Access Compliance Report

Public Rights-of-Way

(Curb Ramps)

Intersection ID: 4155	Main Street: ANDREW_JAMES_DR	Cross Street: OVERLOOK_MOUNTAIN_DR	Location: NE
ADA ID: 04B849EE1F8A	Ramp Type: Perp	Initial Pass/Fail: Fail	Overall Compliance: No
Severity Score: 12.5			
Codes/Mitigation Info/Possible Solution		Field Measurements/Component Compliance

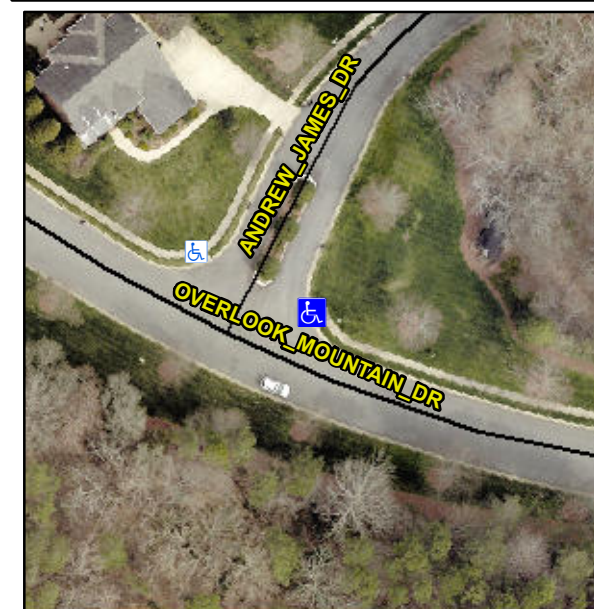
Not Found, R304.2.2

Compliance	Description	Data	Compliance	Description	Data
N/A	Ramp Length (in)	47.0	No	Ramp Slope (%)	8.9
Yes	Ramp Width (in)	48.0	Yes	Ramp XSlope (%)	2.0
N/A	Flare Type LT	N/A	N/A	Flare Type RT	N/A
N/A	Flare Slope LT (%)	N/A	N/A	Flare Slope RT (%)	N/A
N/A	Flare Traversable LT?	N/A	N/A	Flare Traversable RT?	N/A
N/A	Landing Length (in)	N/A	N/A	DWS Provided?	N/A
N/A	Landing Width (in)	N/A	N/A	DWS Contrast?	N/A
N/A	Landing Slope (%)	N/A	N/A	DWS Length (in)	N/A
N/A	Landing X Slope (%)	N/A	N/A	DWS Full Width?	N/A
N/A	Landing Curb? (Y/N)	N/A	N/A	DWS Offset (in)	N/A
N/A	Shared Landing?	N/A			
N/A	Gutter Ponding?	N/A	N/A	Gutter Slope (%)	N/A
N/A	Gutter Lip Ht (in)	N/A	N/A	Gutter X Slope (%)	N/A
N/A	Painted X Walk1?	No	N/A	Painted X Walk2?	N/A
	X Walk 1 Direction	To NW		X Walk 2 Direction	N/A
N/A	X Walk 1 Width (in)	N/A	N/A	X Walk 2 Width (in)	N/A
	X Walk 1 Slope (%)	0.6		X Walk 2 Slope (%)	N/A
	X Walk 1 X Slope (%)	0.2		X Walk 2 X Slope (%)	N/A

Remove & Replace Entire Ramp.
